AGENDA
CANBY PLANNING COMMISSION
REGULAR MEETING
City Council Chambers
Monday, August 22, 1994

**RE: City Council Remand of SUB 94-02 for further review and
submittal of additional information by the applicant
SUPPLEMENTAL STAFF REPORT**

- STAFF REPORT -

DR 94-12

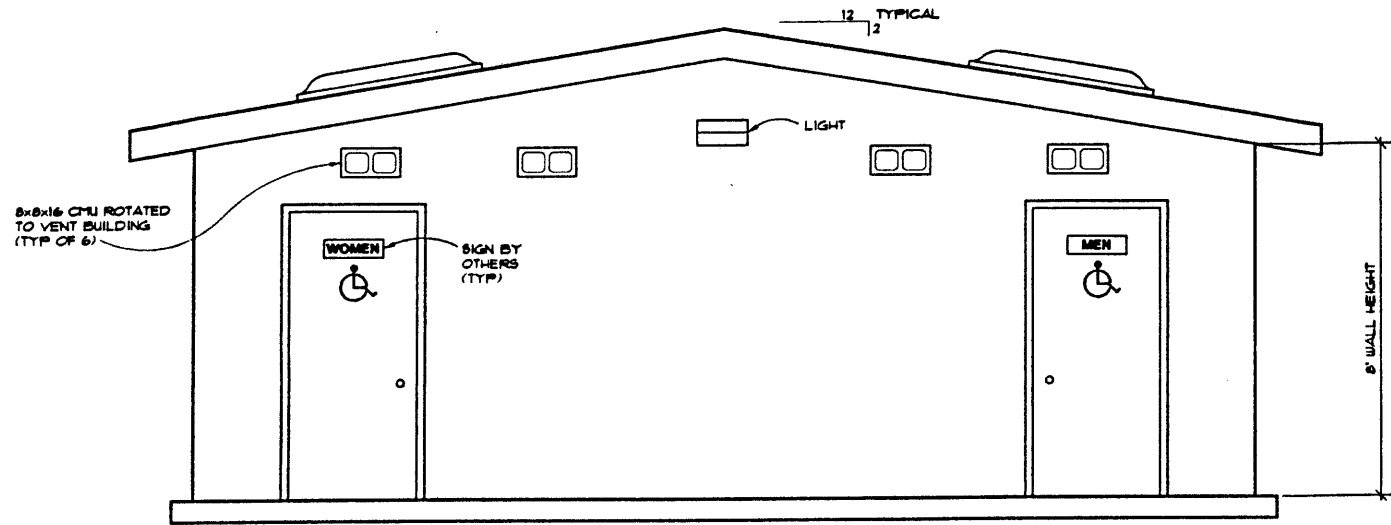
Sidewalk should extend Full Length of street Frontage. With no ON Street PARKING Allowed in this area - Should a PARKING Lot be built into PARK?

A driveway should be provided For MAINTENANCE equipment TO ENTER + EXIT.

5. The sidewalks along the street shall be extended to the full width of the property; and
6. The dotted areas on the site plan shall be lawn areas.

4. The basketball court shall be sited such that it is a minimum of 40 feet from all residentially occupied structures.
5. The rest room shall be sited to provide a minimum of a 20 foot front yard and 7 foot side yard.
